September 15, 2026

**Re: Addendum to Environmental Noise Brief
Base31, Village A – Southern Medium Density Block
Proposed Residential Development
Picton, ON
File: 124-0240-110**

This Addendum has been prepared to update the noise control measures based on the revised layout for the site.

Table 3 and Figure 2 summarize the updated noise control requirements for the site.

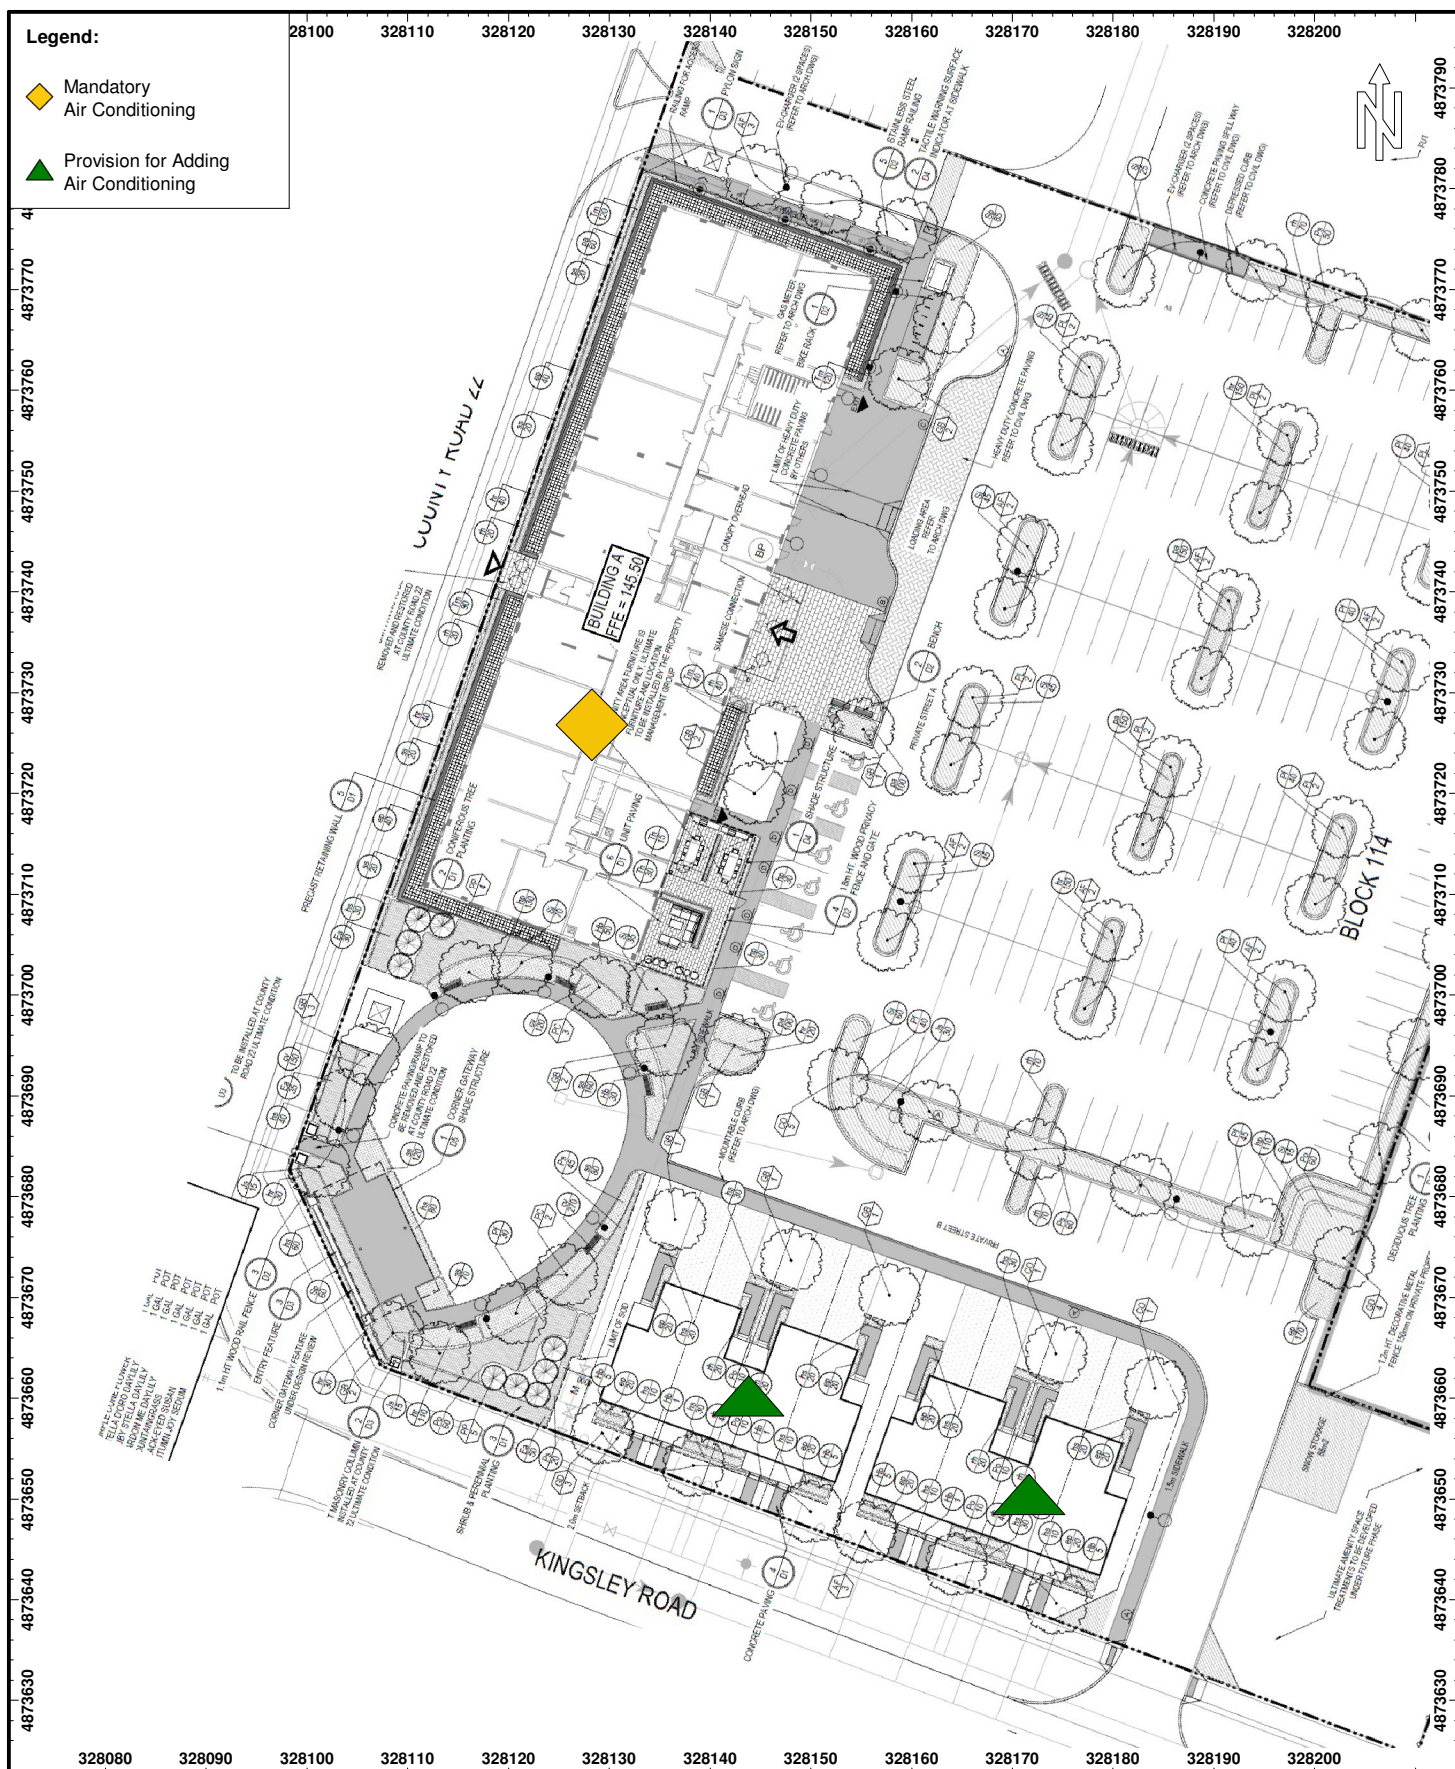
Attachment B contains the calculation details for the outdoor amenity area, at a receptor point representing the center of the rectangular-shaped area. The predicted daytime sound level at this location is $L_{eq, Day}$ 55 dBA, which meets the target sound level from the MECP noise guideline NPC-300.

Based on the updated assessment, a sound barrier is no longer required for the outdoor amenity area of Building A.

SHEET
L1

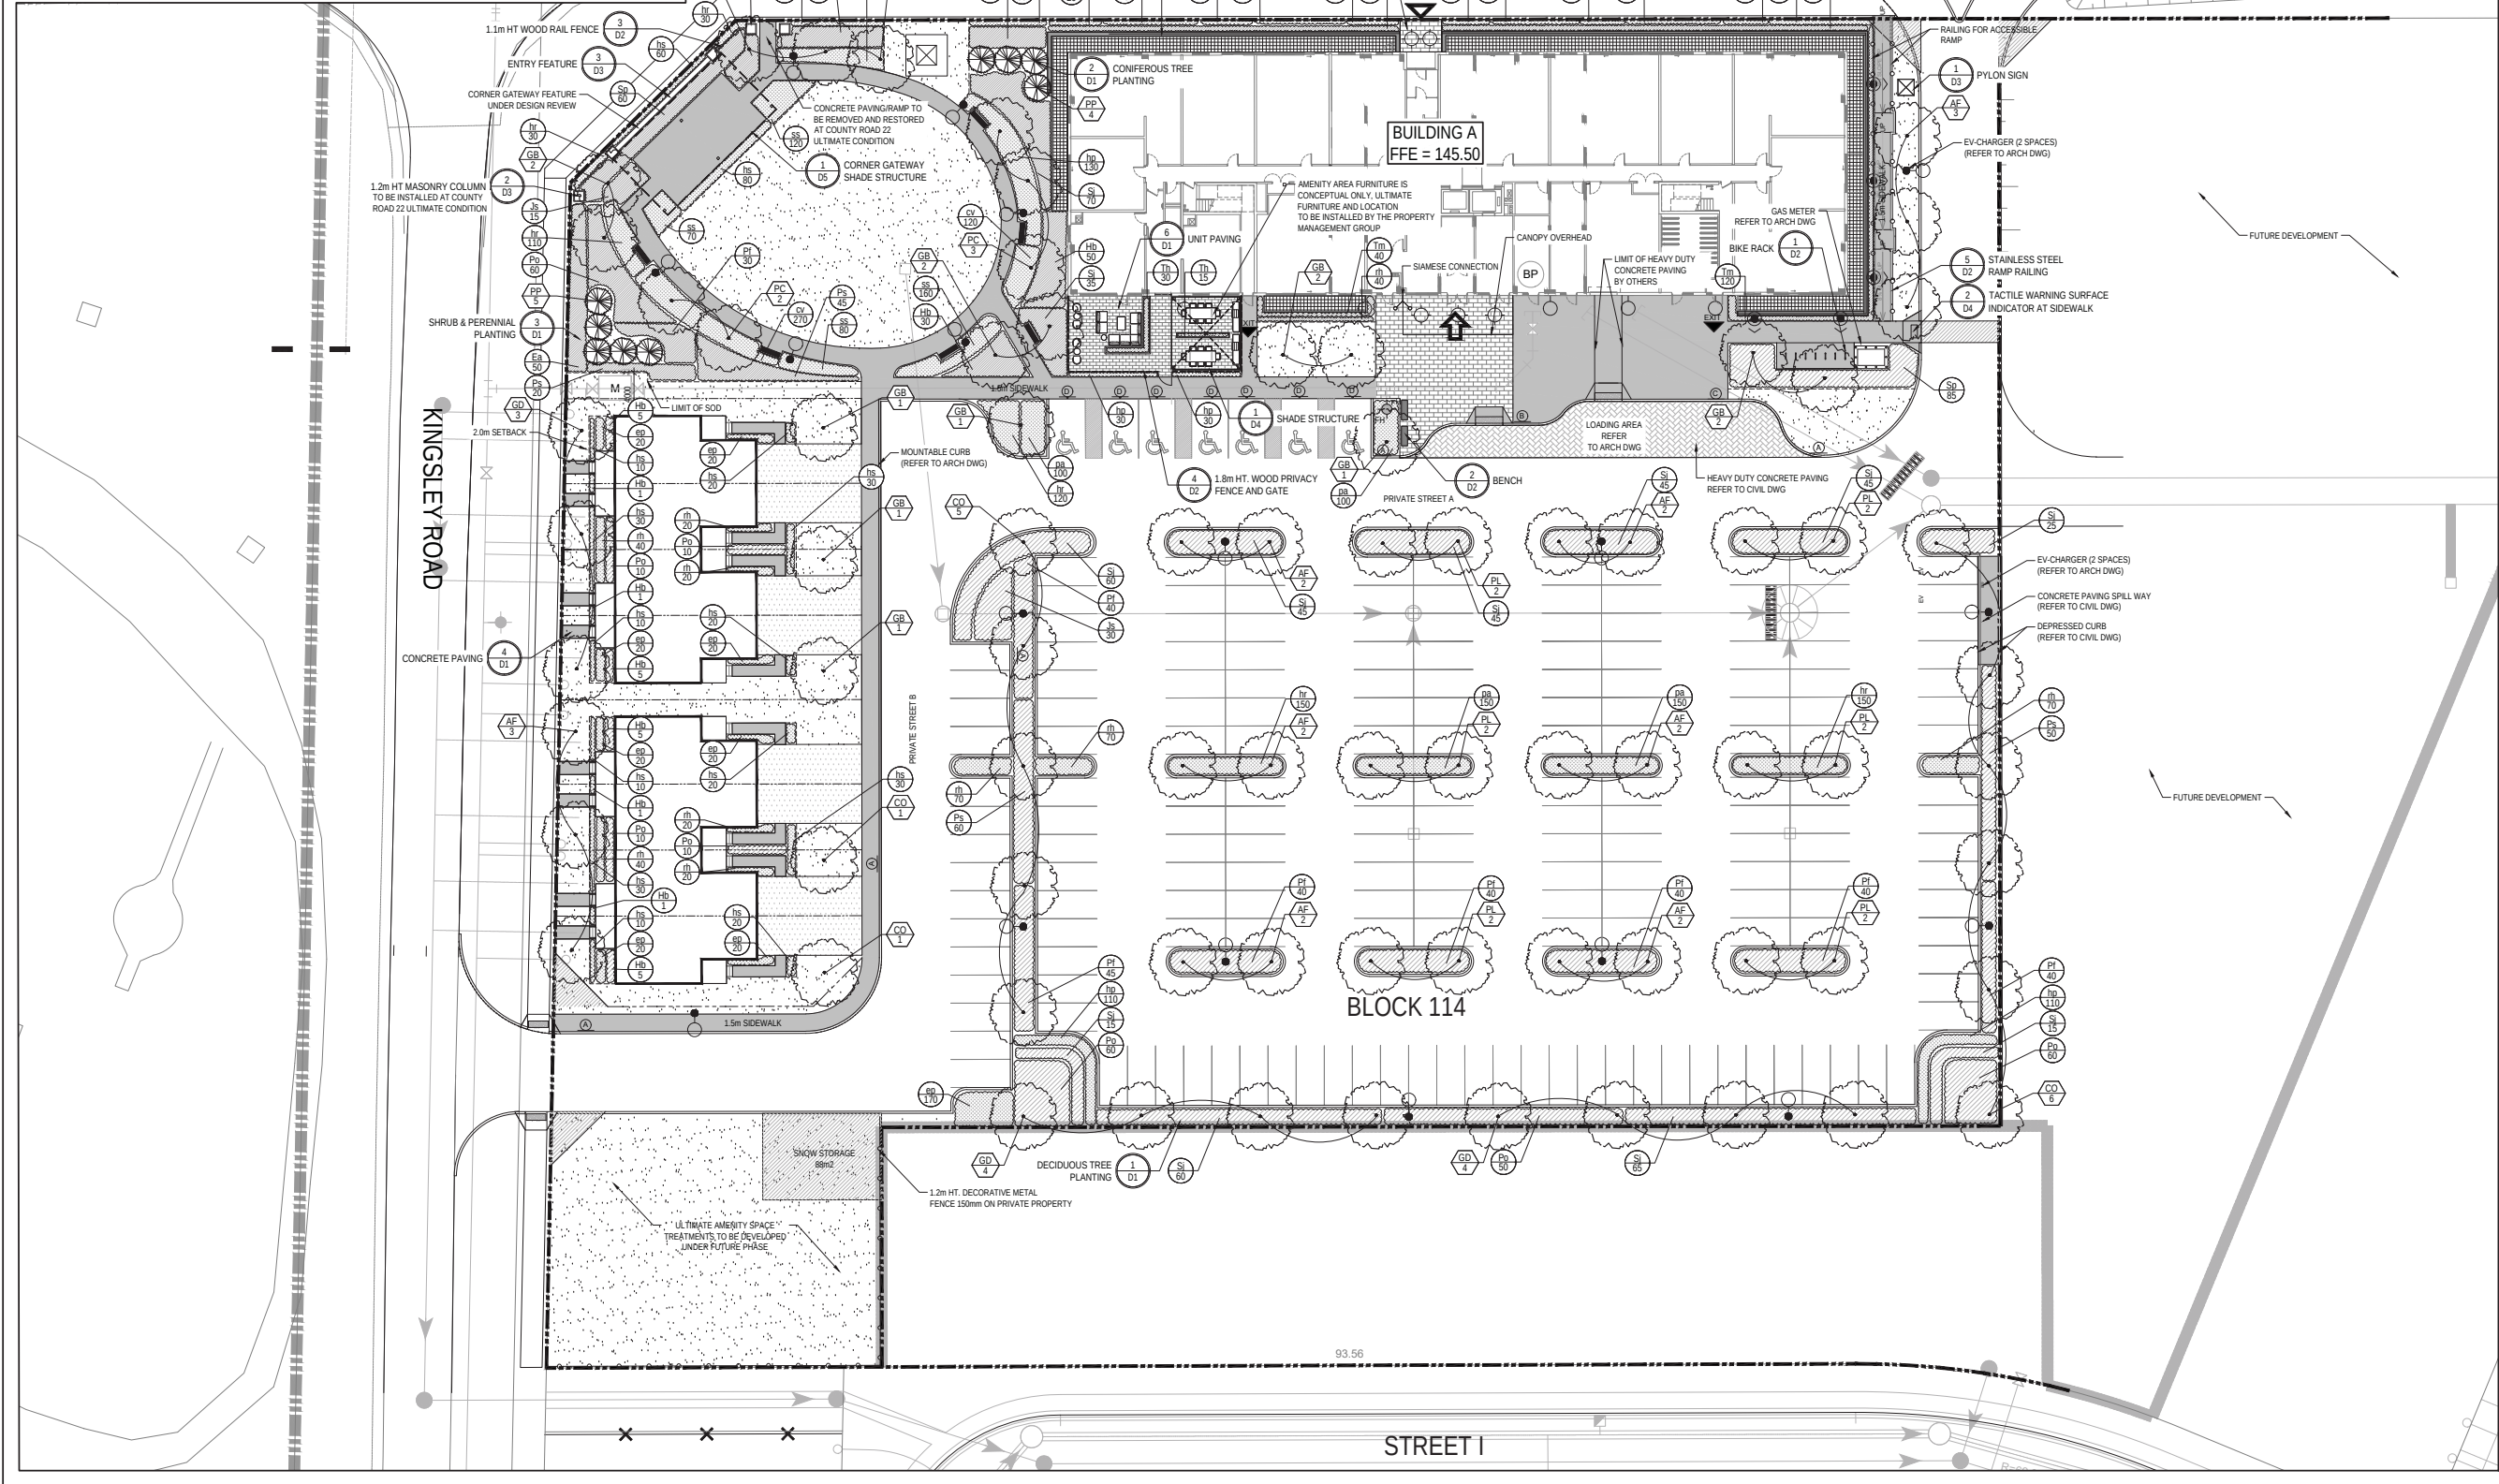
The updated assessment is based on the Landscape Plan prepared by Nak Design Strategies dated July 24, 2026. Attachment A contains the site plan

The overall layout of the site is the same as in the Noise Brief, with the only significant change affecting the noise assessment being the relocation of the Building A outdoor amenity area, from the south side of the building to the east side. This relocation reduces the exposure of the outdoor amenity area to the roadways (particularly County Road 22).
